UNITED STATES PATENT AND TRADEMARK OFFICE

APPLICATION NO.	FILING DATE	FIRST NAMED INVENTOR	ATTORNEY DOCKET NO.	CONFIRMATION NO.
10/684,021	10/10/2003	Kenneth Turos	2067.030	3201

Office Action Summary	Application No. 10/684,021	Applicant(s) TUROS, KENNETH	
	Examiner Sara Addisu	Art Unit 3722

DETAILED ACTION

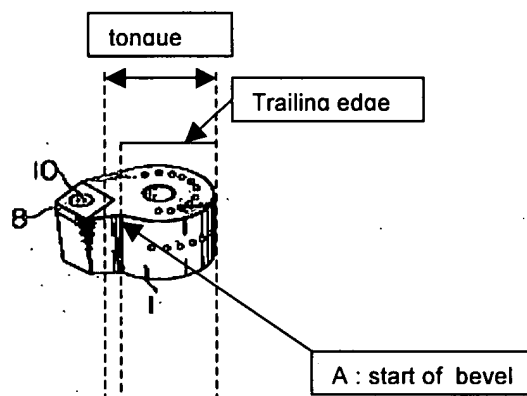
Regarding claims 1, in response to Applicant's assertion on page 14, lines 24-27, that "the term "coupler" is defined by applicant as including ... a tongue formed in one end of the swivel member that is removably and rotatably mountable in the slot formed between the two bar extensions of the arm", it is noted that although the claims are interpreted in light of the specification, the limitation of the term "coupler" are not read in claim 1. As the Applicant pointed out on page 14, line 27 of the Remark, the limitation of the term "coupler" is introduced in dependent claims 2-3. Suzuki (U.S. Patent No. 4,057,884) teaches one end of the elongated shank (arm) (11) having spaced limbs with opposing bores (a plurality of monolithically formed bar extensions) (12 & 13) to create a recess (slot) (15) to rotatably receive body portion (monolithically formed tongue) (2) formed at one end (i.e. trailing end) of the swivel member (1).

In response to Applicant's assertion on page 14, lines 28-29, that "Suzuki Patent does not disclose a hole formed in one end of the tongue", Applicant is referred to Suzuki, '884, Figure 1, which shows tongue (2) having a hole (4).

In response to Applicant's assertion on page 14, line 33- page 15, line 6 that Suzuki Patent does not disclose a partially beveled edge formed in the trailing edge of

the tongue for restricting movement of the swivel member, Applicant is referred to the diagram below where the trailing edge of the tongue is indicated. It should be noted that Suzuki teaches a partially beveled edge (starting at A) formed in the trailing edge for restricting movement of the swivel member by engaging ball (26) with one of the recesses (6) located in the beveled section of the trailing edge ('884, Col. 2, lines 49-55). With regards to the "means for locking" recited in claims 1 and 19, the limitation meets the three-prong test per MPEP 2181 and thereby invokes 35 U.S.C. 112, 6th paragraph. Suzuki teaches ball (26) being engaged with one of the recesses (6). Ball (26) and recess (6) are capable of performing the identical function "positioning the cutter in relationship to a surface of the workpiece" in substantially the same way (swinging swivel member to a desired position) and produces substantially the same result (indexing cutter/positioning cutter in relation to a workpiece) as a bevel.
